**BRIO REFINING SUPERFUND SITE
HOUSTON, TEXAS
AMENDED RECORD OF DECISION
DECLARATION**

**BRIO REFINING SUPERFUND SITE
HOUSTON, TEXAS
AMENDED RECORD OF DECISION
DECISION SUMMARY**

**BRIO REFINING SUPERFUND SITE
HOUSTON, TEXAS
AMENDED RECORD OF DECISION
RESPONSIVENESS SUMMARY**

PROJECT	9-10-78	ISSUE #	0-0
DATE	11/12/82	ISSUE #	0-0
BY	WJW	DATE	
APP.	AS Shuman	FIGURE #	FIGURE 2

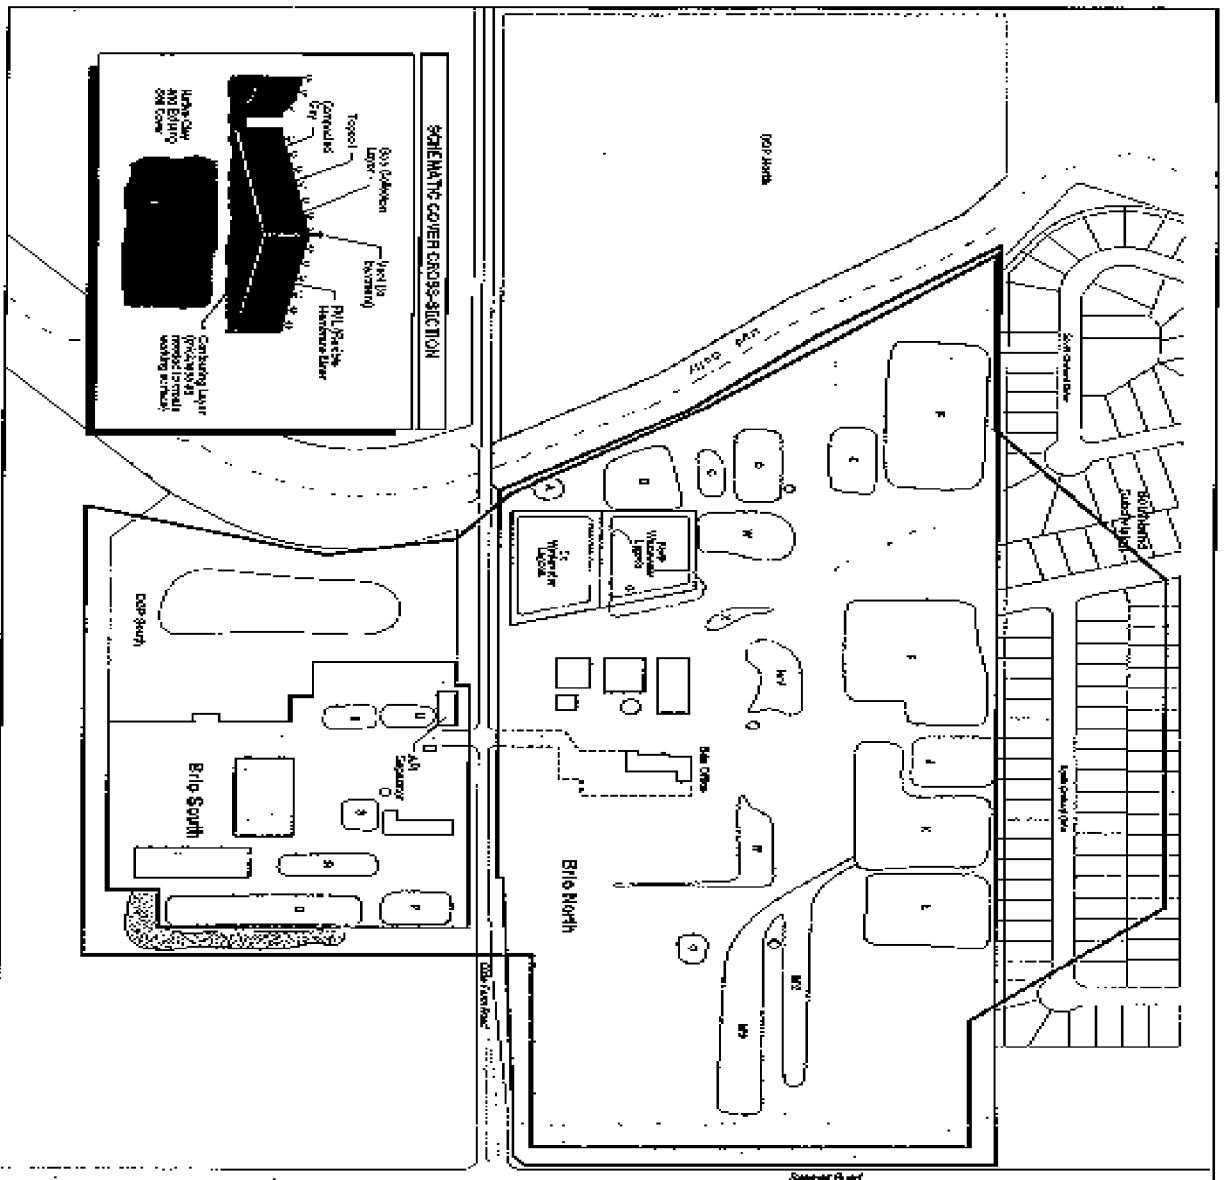
19. Comment - The description of the composite cap should be clarified in the text to note that the cap will not be installed to the limits of the barrier wall over DOP South.

Site Cover - A composite cap will be constructed over the site, extending to the limits of the barrier wall (not including Dixie Oil Processors South, see Figure 2). The cap will include a gas collection layer, a flexible membrane liner, compacted clay, and top soil to promote vegetative growth.

Response: The text has been modified to incorporate this comment.
